**CAPITAL REGION INTERNATIONAL AIRPORT
CARGO RAMP EXPANSION (PHASE 2 & 3) AND DEICING CONTAINMENT FACILITY
LANSING, MICHIGAN**

**AIP GRANT No. 3-26-0055-065-2023
RS&H No. 1010-0095-000**

**ADDENDUM NO. 2
February 10, 2023**

SHEET NUMBER
E201

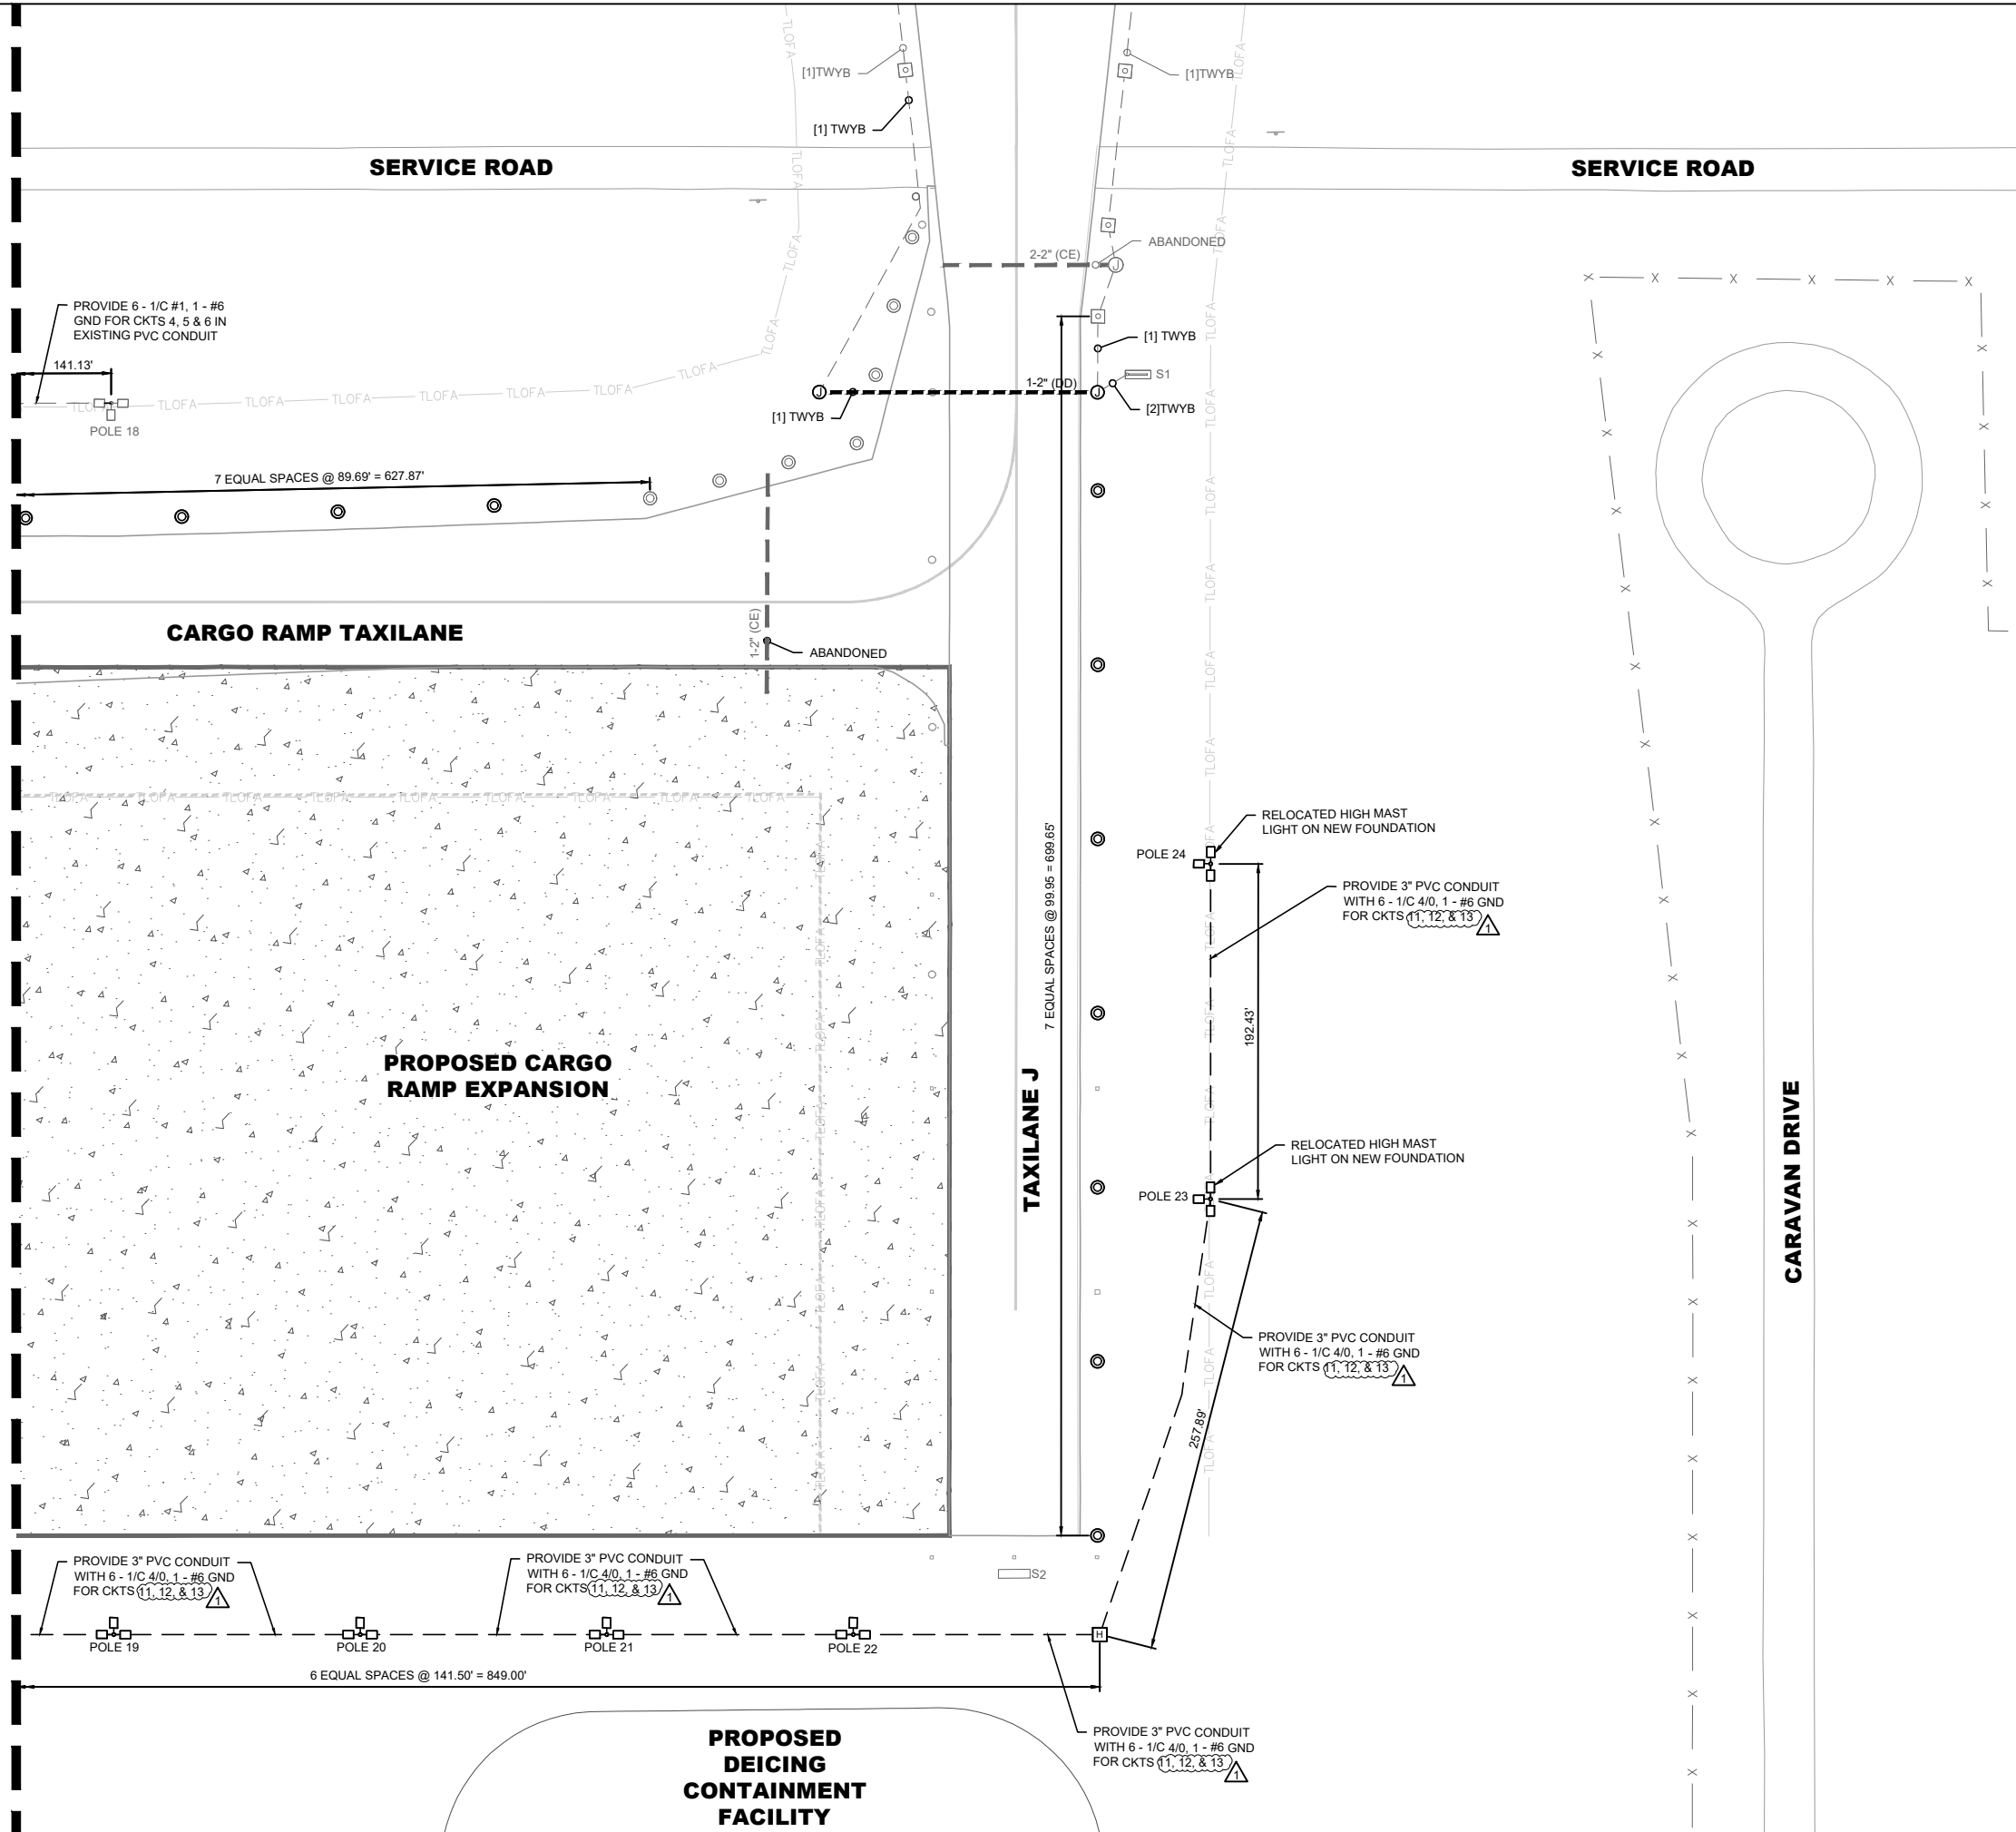
- *REMOVE plan sheet E201 and REPLACE with attached plan sheet E201 / ADD-2. Circuit numbers have been changed and an existing handhole near High Mast Pole 16 is shown.*
- *REMOVE plan sheet E202 and REPLACE with attached plan sheet E202 / ADD-2. Circuit numbers have been changed.*
- *REMOVE plan sheet E503 and REPLACE with attached plan sheet E503 / ADD-2. A new Detail 3 has been added—"DIRECT BURIED CONDUIT DETAIL – 1 WAY, 3" PVC".*
- *REMOVE plan sheet E505 and REPLACE with attached plan sheet E505 / ADD-2. Circuit numbers have been changed.*
- *ADD plan sheet E601 to the plan set.*

E503

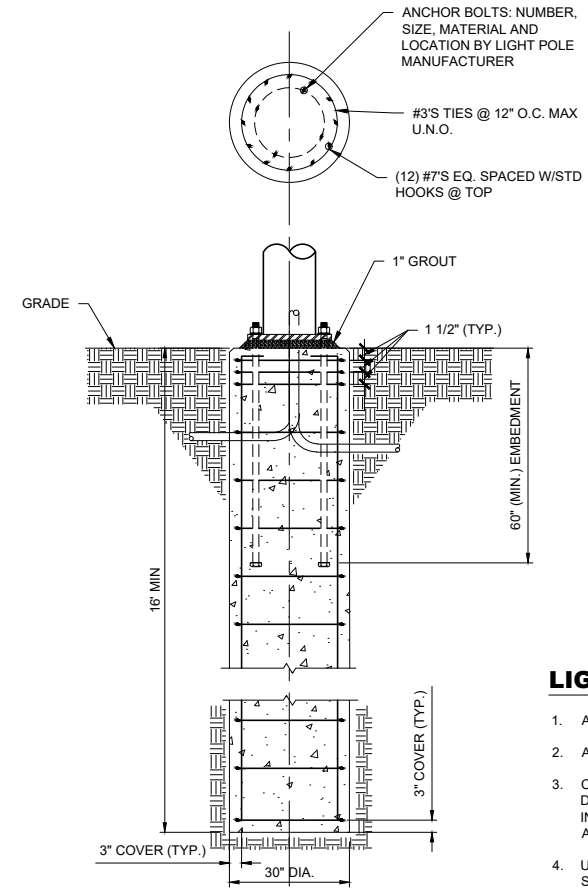
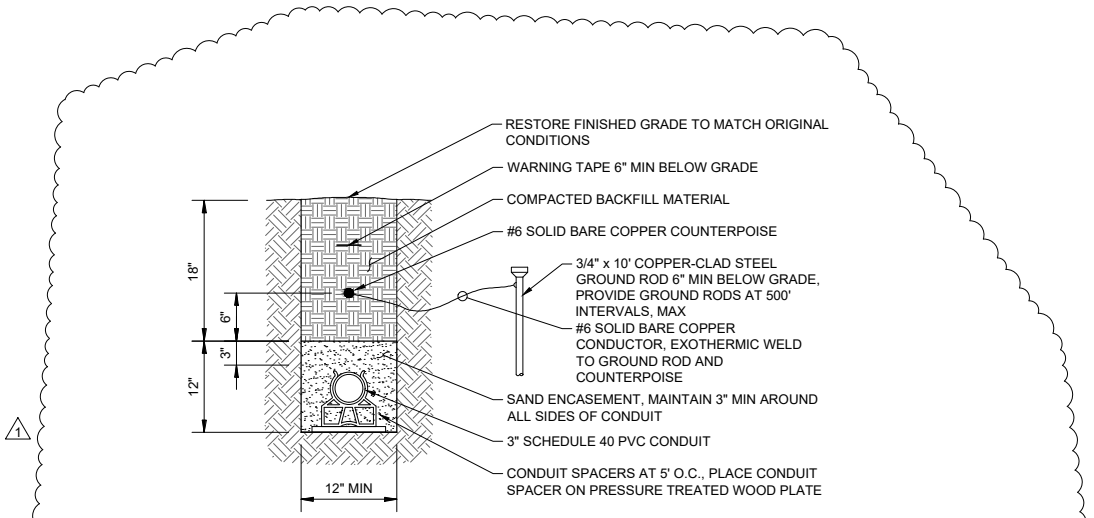
Plan Sheet E503 / ADD-2
